Planning &
Environment

**STATE SIGNIFICANT DEVELOPMENT
ASSESSMENT REPORT:**

***Sydney International Convention, Exhibition and
Entertainment Precinct (SICEEP), Darling Square
(formally The Haymarket), North Plot, Darling Harbour***

SSD 7021

Figure 7: View of the northern (left) and southern (right) elevations of the Darling Exchange building contained within Stage 1 Approval maximum North Plot building envelope (purple) (Source: Applicant's RtS Addendum)

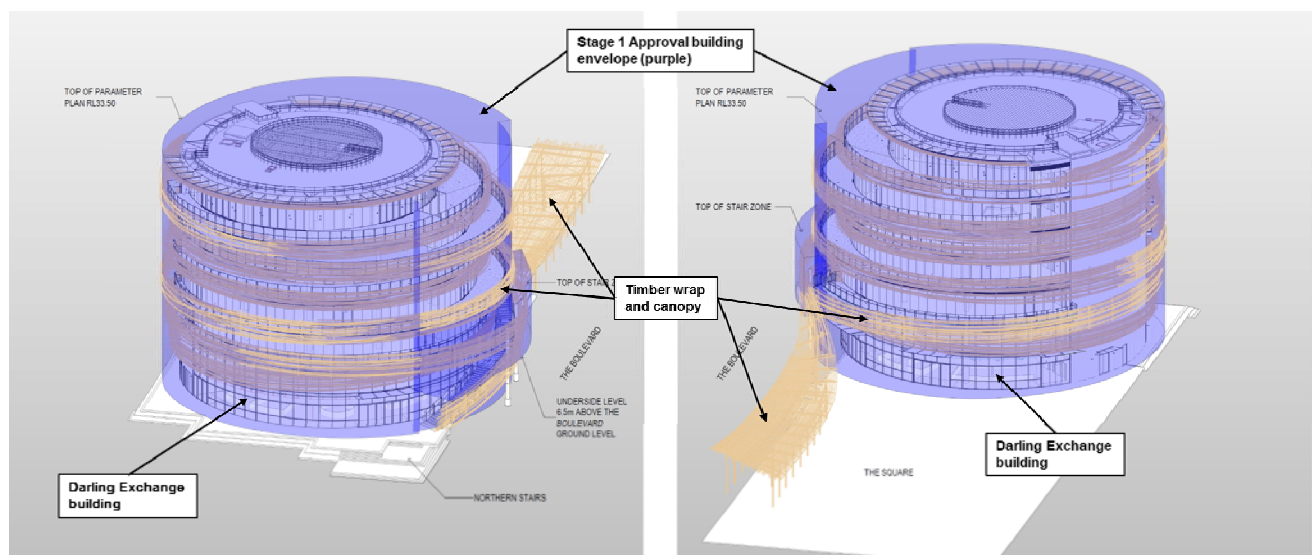
Council raised concern that as the approved building envelope for the North Plot (and across the Darling Square precinct) are larger than the building form actually proposed, there may be an expectation these volumes be developed at a later stage via a modification application. Council

Minor sections of the timber strips/ribbons (the timber wrap), that encase the Darling Exchange Building (discussed further at **Section 5.4**), extend up to 500 mm beyond the building envelope (shown in purple at **Figure 7**). However, this is considered acceptable as the parameter plans allow for a 500 mm 'articulation zone'. Furthermore, the extension of the timber wrap out into the public open space to form an open lattice canopy (discussed further at **Section 5.4**), is considered to constitute an ancillary public domain structure and therefore not part of the building envelope. The timber wrap that encases the external stair which encroaches into the Boulevard is also acceptable as discussed in **Section 5.3.2** below.

The Department notes Council's concerns that the proposed Darling Exchange building fills approximately 80 percent (%) of the entire building envelope. However, the Department does not agree the Stage 1 building envelope needs to be modified as it provides a maximum building extent together with an allowance for GFA within the overall volume. The Department notes the proposed floorplates have been shifted and cantilevered relative to each other and considers the design response within the approved envelope is acceptable.

Figure 9: The proposed 4.6 m encroachment into the 19 m ground floor level separation distance (shaded in yellow) (Base source: Applicant's RtS)

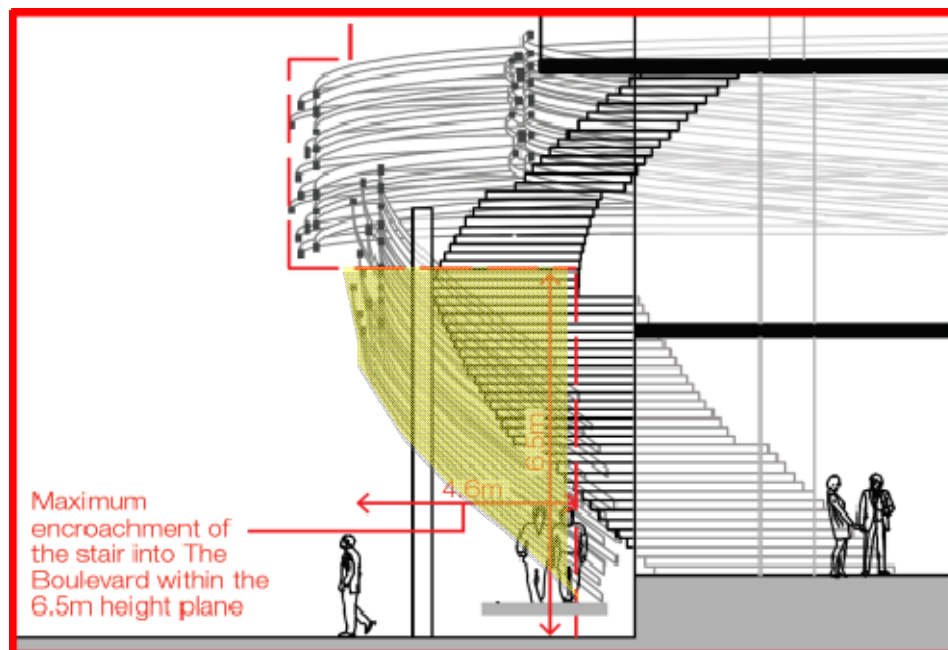
The proposed Darling Exchange building public stair encroaches into the 19 m ground floor level separation distance by a maximum of 4.6 m, therefore reducing the separation distance to a minimum of 14.4 m at its narrowest point (refer to **Figure 9**).

The Department considers maintaining the 19 m width of the Boulevard is a critical consideration in achieving the north/south pedestrian connection and visual links from China Town to Darling Harbour. However, the potential for an encroachment into the Boulevard was considered in the Department's previous assessment of the Stage 1 Approval, and was accepted in principle subject to a number of performance criteria outlined in FEAR B4A. The Department has considered the criteria in FEAR B4A, as well as the Applicant's justification in **Table 8**.

Figure 18: Amended servicing facilities for the Darling Exchange building (Base source: Applicant's RtS)

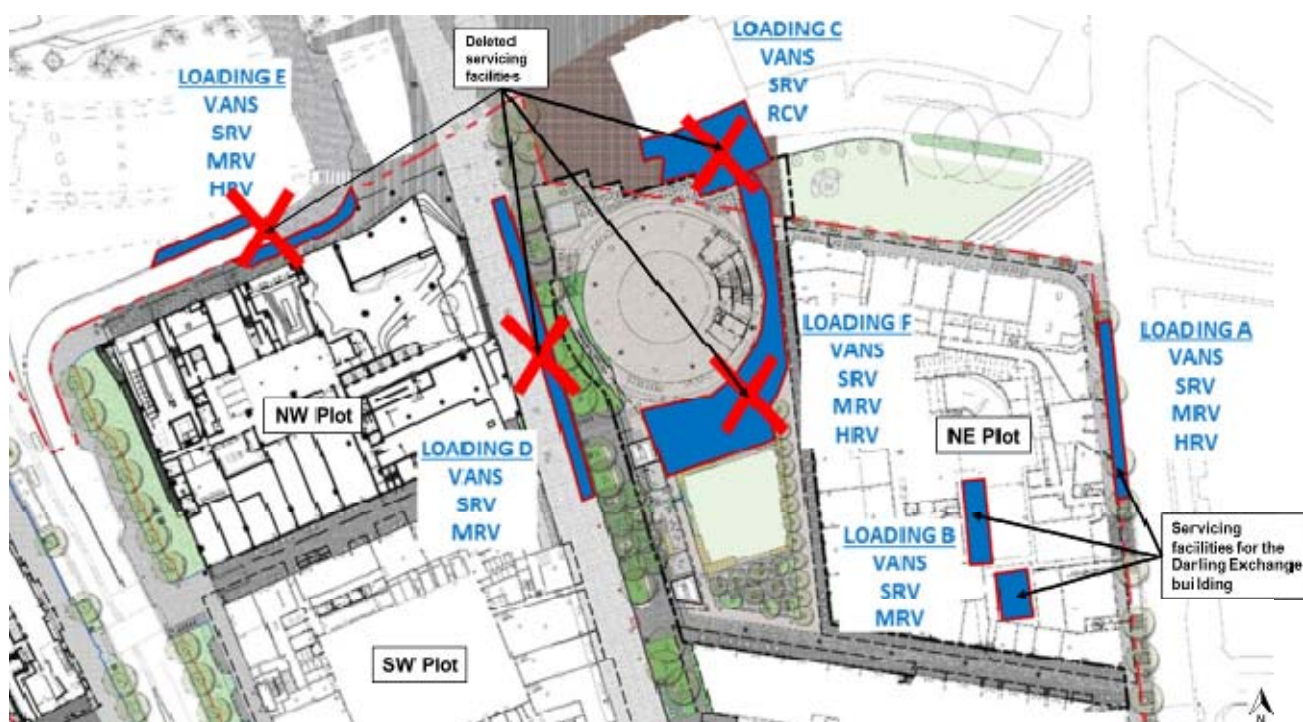
The Department, Council, TfNSW and PNSW raised operational, safety and visual impact concerns about the proposed servicing arrangements. In response, the Applicant deleted all servicing within the public domain (excluding the Harbour Street bay, which is retained) and modified the North East Plot development (SSD 6626 MOD 2) to accommodate servicing for the Darling Exchange building as shown at **Figure 18**.

In its assessment the modification application to the North East Plot (SSD 6626 MOD 2) the Department concluded the North East Plot is capable of accommodating the servicing requirements of the Darling Exchange building. In addition, it is a condition of the North East Plot SSD consent that:

- the Applicant prepare a loading dock and service vehicle management plan to ensure the space is appropriately managed; and
- the use of the North East Plot for the servicing of the Darling Exchange building is registered on title.

Figure 19: Winter Solstice shadow cast by the Darling Exchange building at noon (shaded in pink) and the North Plot building envelope (red line) (Base source: Applicant's RtS)

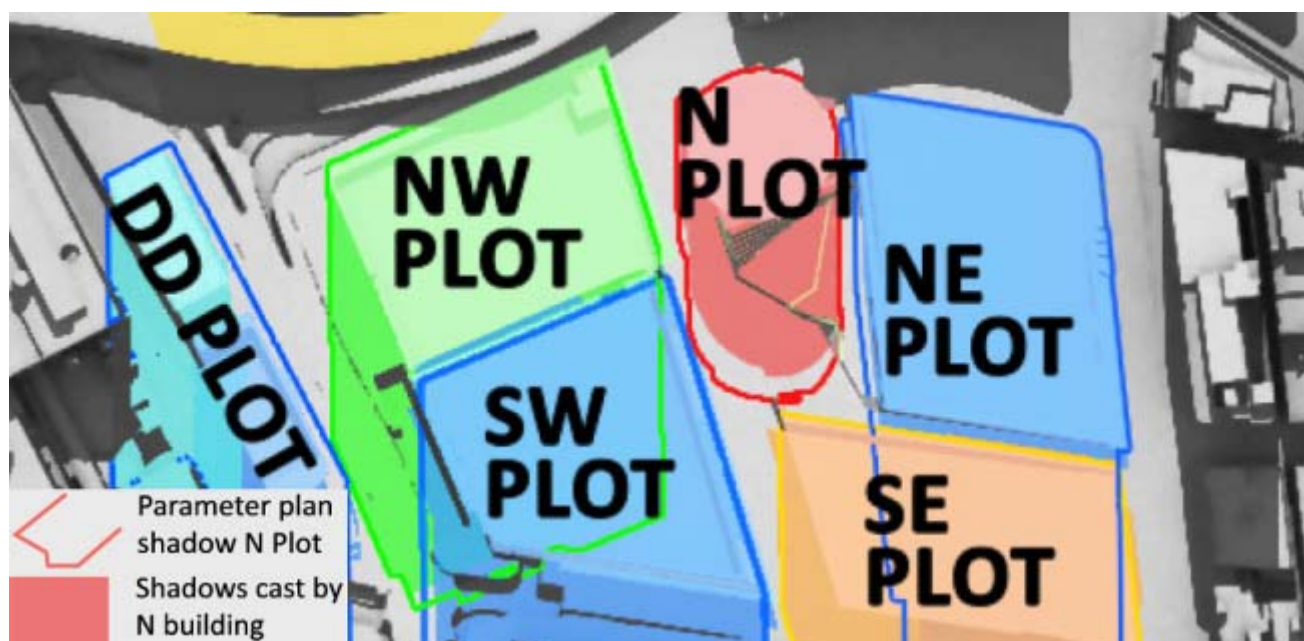
Concern was raised in the public submission about the potential overshadowing of the public open space. PNSW has also commented that the height of the Darling Exchange building should not result in additional overshadowing of the public square above what was approved by the Stage 1 Approval.

The Applicant contends the height of the Darling Exchange will provide for a building of an appropriate civic scale. Further, the proposal is wholly contained within the approved North Plot building envelope (refer to **Figure 19**).

The Department is satisfied the proposal will not result in unacceptable overshadowing impacts on the public open space, as:

- the shadow studies submitted with the proposed modification demonstrate the proposal has an acceptable impact on solar access to Darling Square open space in accordance with the conclusions of the Concept Approval (**Figure 19**) and will ensure the southern portion of the public open space would continue to achieve direct sunlight between 11:30 am and 1:30 pm in mid-winter;
- the Darling Exchange building is of a lesser scale than the maximum size of the North Plot building envelope, and includes cantilevered levels, which allow for additional sunlight to penetrate through to the open space in winter months; and
- the height of the Darling Exchange building matches the podium heights of the other Darling Square buildings facing the open space.
